APPENDIX 3

HYDRO GROUP AIR STRIPPING INSPECTION REPORTS

INSPECTION REPORT #2922-92-1

APPENDIX 4
DPH INSPECTION REPORTS

Photo 1 ->

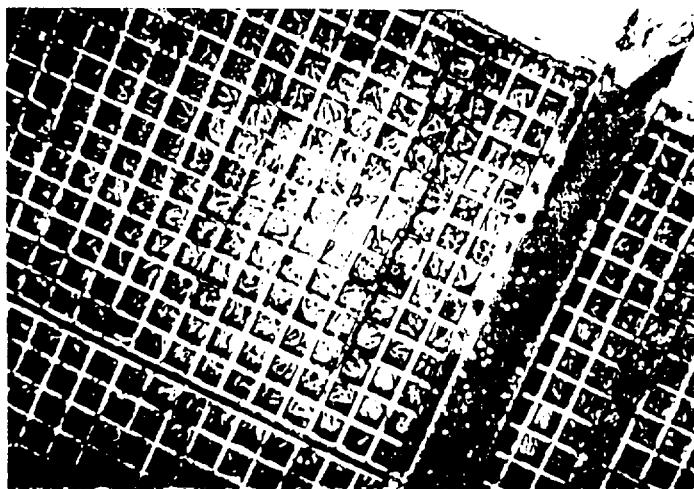
Manway #1 allowed access to the area above the mist eliminator. The mist eliminator was shifted out of the way to inspect the distributor tray surface and the top of the packed bed. The distributor tray and visible packing were slightly stained black with manganese oxide. No heavy build-up was evident. There were some pit formations present on the distributor tray surface.

1. Distributor Tray and Top of Packed Bed - Note the dark manganese oxide stains on the tray and packing surfaces, and the light colored pit formations on the tray.
2. Bottom of Packed Bed - Note the dark colored manganese oxide stains on the support plate and packing.
4. Tower Sump - Note the light colored pit formations on the sump floor.

An annual inspection program is recommended to monitor the manganese deposition and the pit formations for potential problems.
